Technical Service Bulletin

**MODEL(S)
AFFECTED:****Tennant T7 Rider Scrubber**

Model serial number range: 10206994→10278484, (In Europe, before s/n T7.....0894)

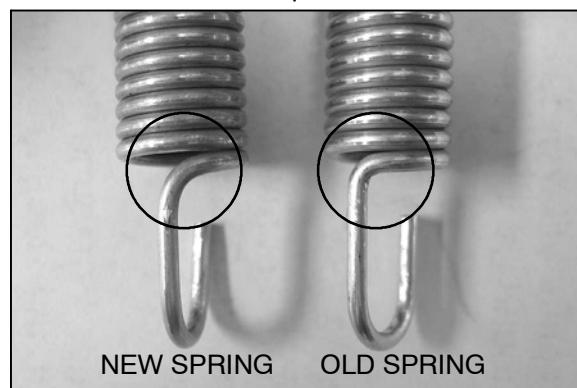
Potential accelerator pedal failure. Although this has occurred in less than 0.1% machines, Tennant mandates immediate machine repairs.

DISPOSE EXISTING SPRINGS AND INSTALL
SPRING REPLACEMENT KIT P/N 9002672

NOTES:9002672 - Kit, Accelerator and Brake Pedal Spring Replacement - Kit includes 2 springs and installation instructions. Kit and installation expense will be covered by Tennant.

NOTE: The new springs have a larger bend radius as shown in this photo.
